**PLANS AND DOCUMENTS
referred to in the PDA
DEVELOPMENT APPROVAL**

Approval no: DEV2020/1099
Date: 9 December 2020

**Re: Further Issues Response – Stormwater and Flooding
Oxley PDA
DEV2020/1099**

Figure 1: 5 year ARI flood inundation within open space zones

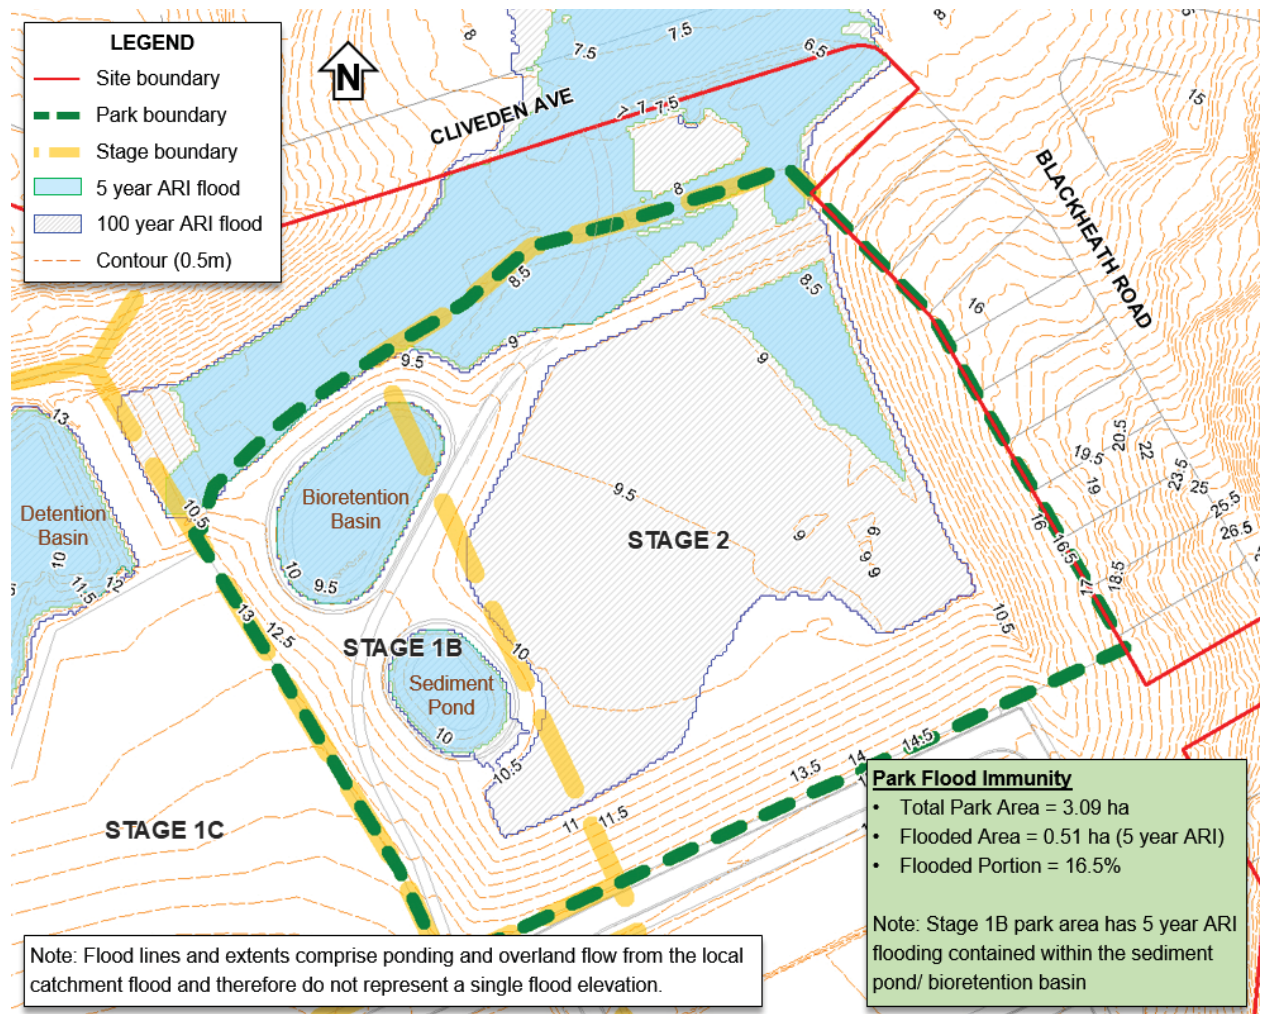
- 20 (a): Demonstrate that a maximum of 30% of the parkland to be provided for Stage 1 is below the 5 year ARI. Where it cannot be demonstrated that compliance can be achieved, consideration should be given to providing a greater area of parkland for Stage 1 from the area shown on the Master Plan.

The park area (Stage 1B and 2 combined) has 16.5% of the total area below the 5 year ARI flood level as illustrated in Figure 1 (Attachment 1). The design has been resolved such that flows up to the 5 year ARI from the piped stormwater drainage network discharge through the sediment pond/bioretention basin. Only local surface flows from the open space zone (up to 5 year ARI) flow towards the open space flood bund. In major events, flows in excess of the sediment pond/bioretention basin system capacity and overland flow from the development discharge overland through the open space zone. Stage 1B (interim) park area contains the stormwater treatment systems and contains the 5 year ARI within these basins (and discharge structures). Pathways are above the 5 year ARI flood level.
